MINOR VARIANCE REPORT

APPLICATION: CAV A/173/2022

CAV A/173/2022 - 1240 Baldwin Dr (East District) (OP Designation: Low Density Residential)

View of the subject property from the street:

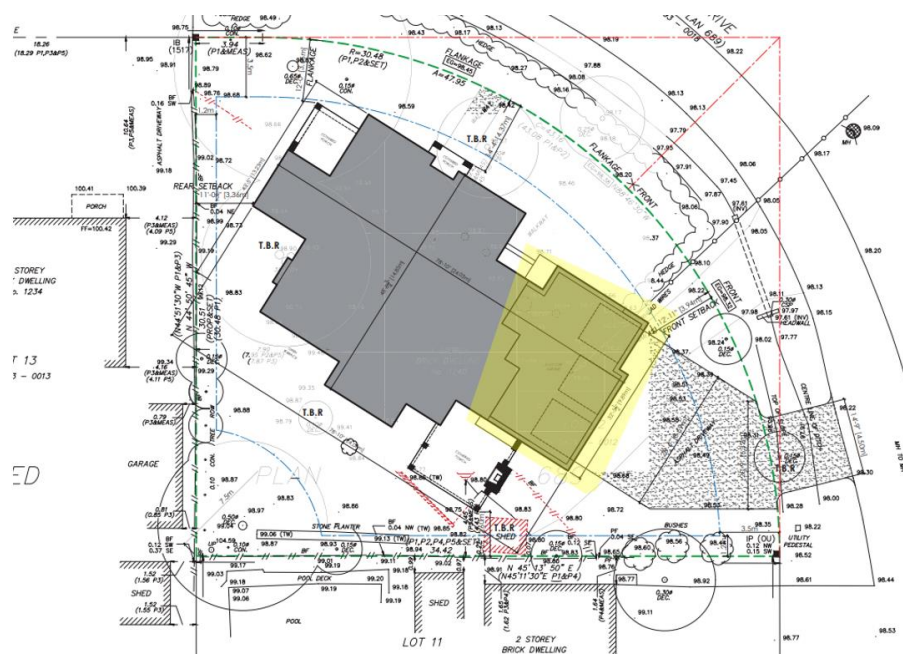
The applicant is requesting relief from Zoning By-law 2014-014, as amended, to permit a decrease in minimum front yard setback from 8.42 metres to 3.94 metres with the decrease of 5.00 m. The front yard is measured from the front property line to the main wall. The intent of regulating the front yard setback is to ensure a relatively uniform setback along the street. In this instance, the proposed dwelling on the subject property located on the curve of Baldwin drive with decrease in front yard setback will be closer to the street appearing visually large on the smaller lot as compared to other dwellings on the larger lot. Staff are of the opinion that the requested variance is not minor in nature and does not meet the intent of the Official plan and Zoning By-law.
